Resource Consent Engineering Assessment Report

Applicant	Ra Tuatahi No. 1 Limited		
Application Description	To construct a solar array		
Application Type	« Appln Type Land use Appln Type »		
Activity Status	« Activity Level Discretionary Activity Level »		
Zone	General Rural		
Address	80 Struie Road, Hororata		
Legal Description	Lot 6 DP 66179		
Valuation No.	2423025500		
Date Sent to Development Engineers	7 January 2025		
Return to Planning by	14 January 2025		
Planner	Jonathan Gregg		
Land Development input	<input checked="" type="checkbox"/>	Victor Mthamo	27 January 2025

Figure 1 shows the site and the proposed array and accompanying infrastructure.

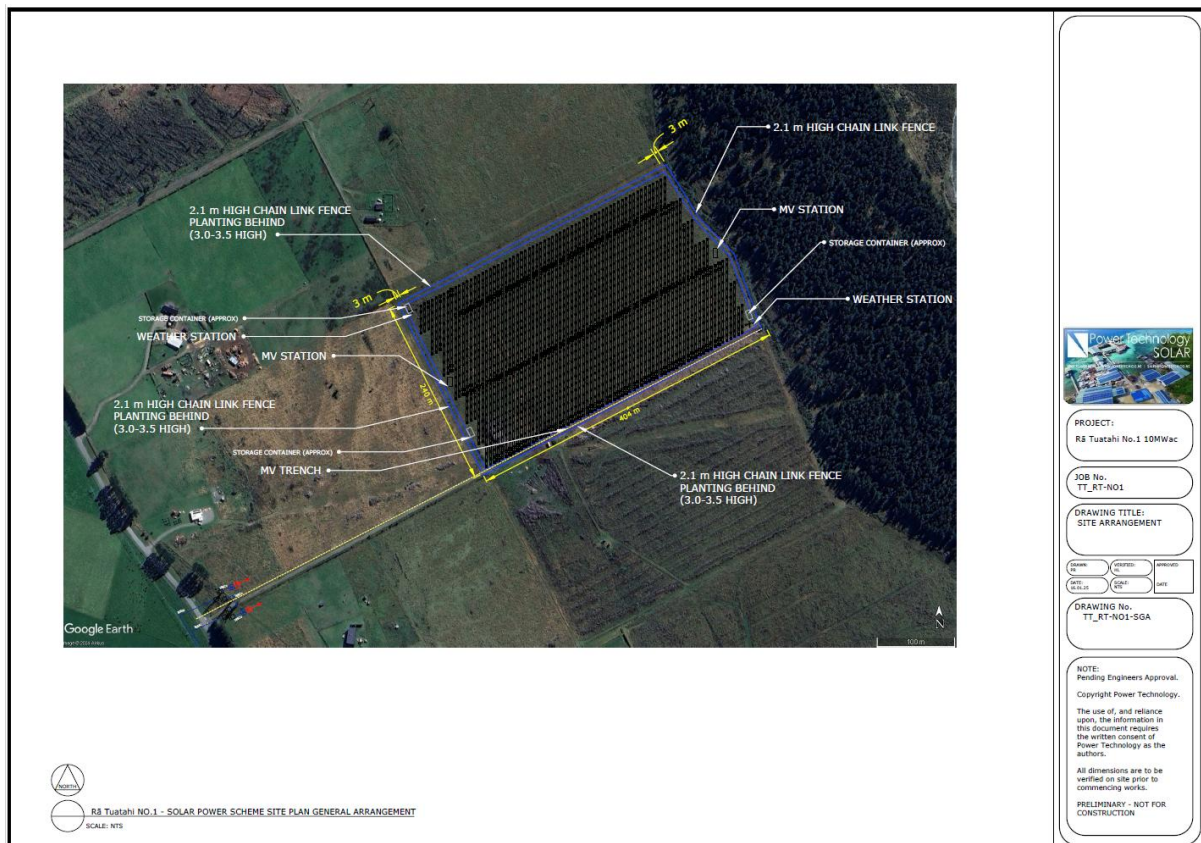
The application seeks to establish a solar array at 80 Struie Road, Hororata. The site is 10.2 ha in extent. The solar array will consist of ground mounted photovoltaic units, ancillary structures including a medium voltage station consisting of two inverter and transformer units.

Figure 2 – 1:200 Year Flood Modelling map

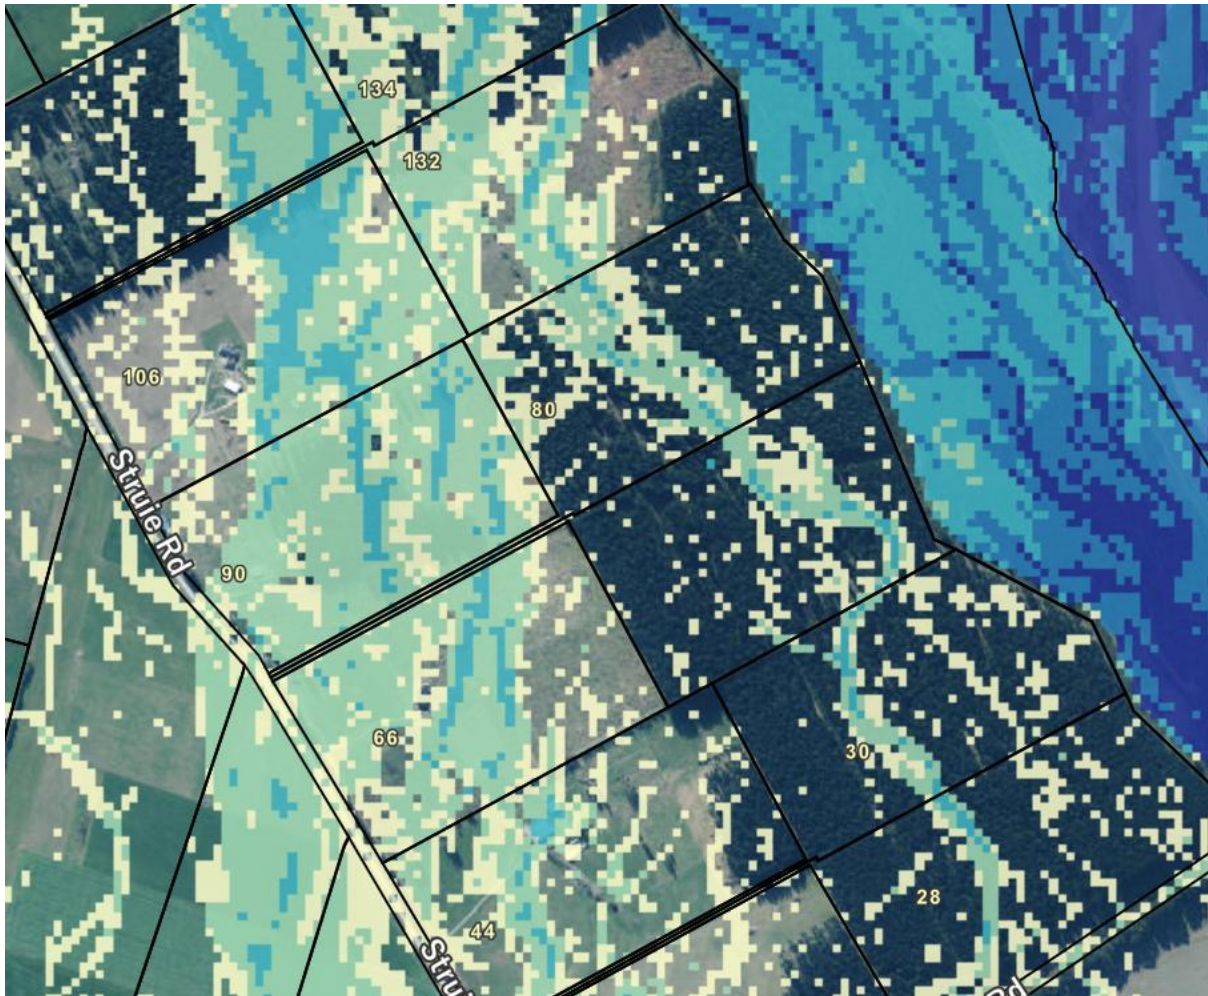
The SDC flood modelling maps show that the site acts as an flood overland flow path during the 1:200 year events (Figure 2). Flood depths within the site during the same events can be up to 0.3 m.

We agree with the PDP assessment that the pre and post development flows will be about the same. This is because the areas below the panels will still be pervious allowing soakage to ground.

We also are of the opinion that the proposal will not affect the overland flow paths to any significant extent because:

- The area below the panels will still be able to let flood flows pass through.
- Of the proposed earthworks there are none that will affect the flood overland flow paths to an extent that will hinder the functioning of the overland flow path.

Standard flooding conditions to be stipulated.
